# **QUIVIRA MINING COMPANY**

Re: **License No. SUA-1473**  
**Docket No. 40-8905**

QUIVIRA MINING COMPANY  
Request For Milestone Extension  
For License Condition 40.A.1

FIGURE 1

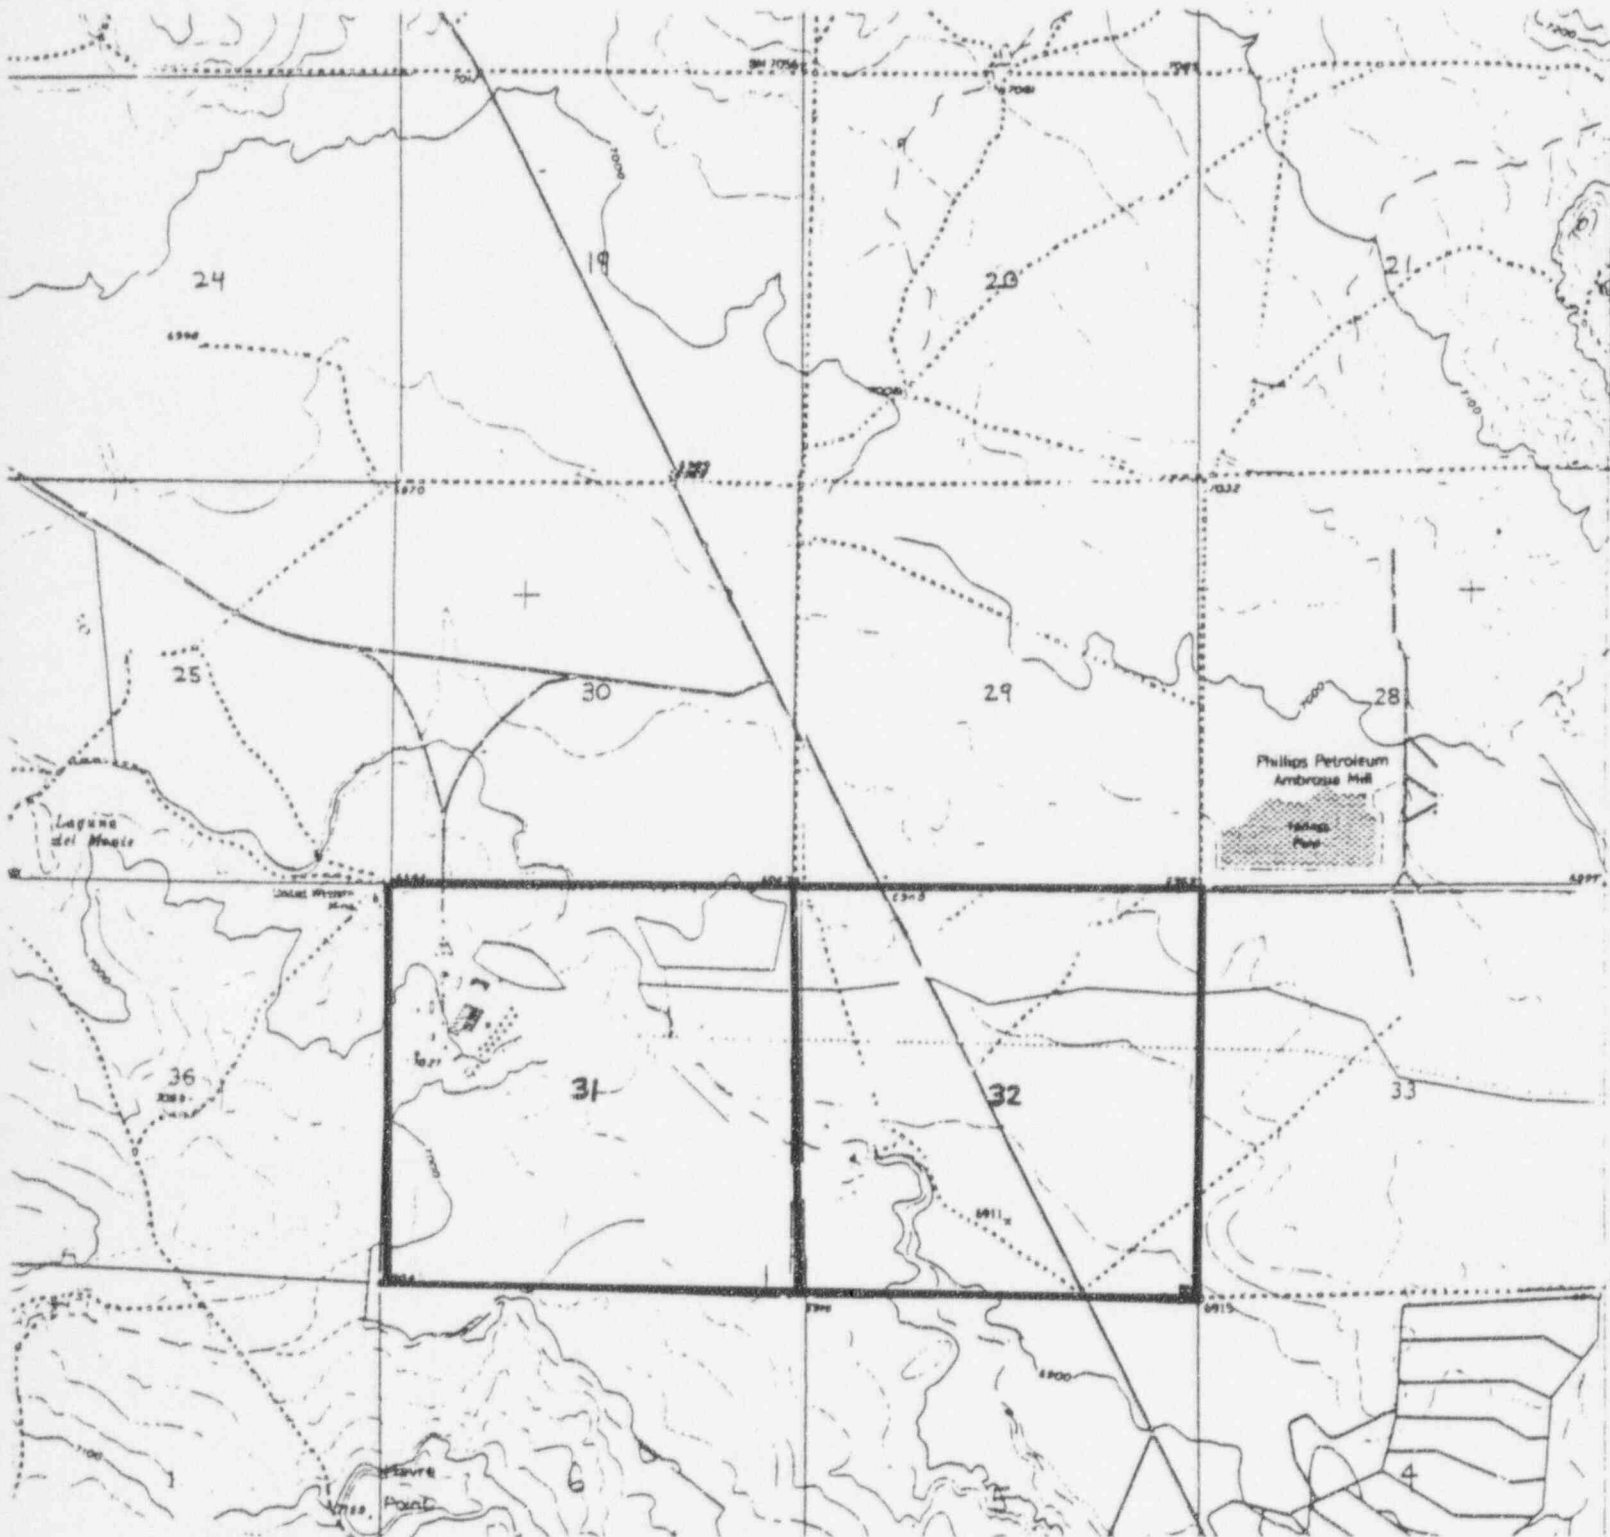
Quivira ultimately received official approval from the State of New Mexico to access the area on May 7, 1997. Upon receipt of the approved permit, Quivira began an initial pass to retrieve windblown tailings on Section 32 in accordance with the conditions stipulated in the permit. Progress has been impeded slightly due to inclement weather during May 1997.
